Service Letter No. 439

**SUBJECT:** Lycoming Service Bulletin No. 300A (Crankshaft Propeller Flange Inspection)

Service Bulletin No. 300A  
Approved by FAA

SUBJECT: Crankshaft Propeller Flange Inspection

Figure 1. Rear View of Propeller Mounting Flange Showing Area of Lightening Holes.

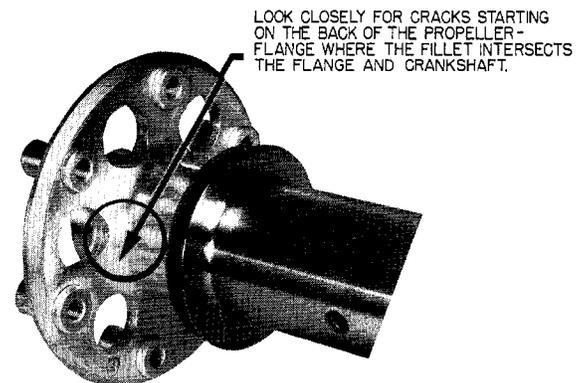
a. Remove the propeller and starter ring gear from the mounting flange of the engine and examine the entire area of the crankshaft flange from the crankshaft seal forward for evidence of cracks. Use a magnifying glass of approximately 10 power and adequate lighting for this purpose or portable magnetic particle test equipment. Pay particular attention to the flange area and fillet radius on rear face of propeller flange. See accompanying illustrations for possible location of where cracks might appear and type of structural damage which can occur. Because of machining marks, the factory does not recommend using dye penetrant for this inspection. Further flight with a cracked propeller flange is not permissible.

Figure 2. 10X magnified view showing appearance of area cracked due to abnormal loading imposed on the propeller flange during periods of unauthorized maneuvers.

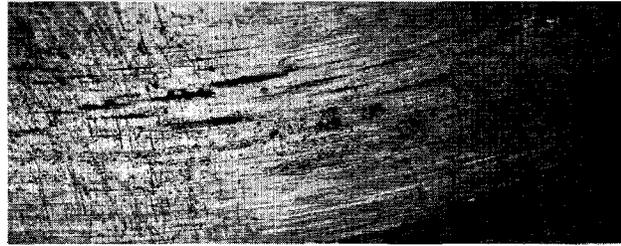
a. During magnetic particle inspection, particular care should be taken to examine the propeller flange area in the large fillet radius tangent to the crankshaft in addition to the normal flange and shaft areas for possible cracks or other evidence which indicates bending.
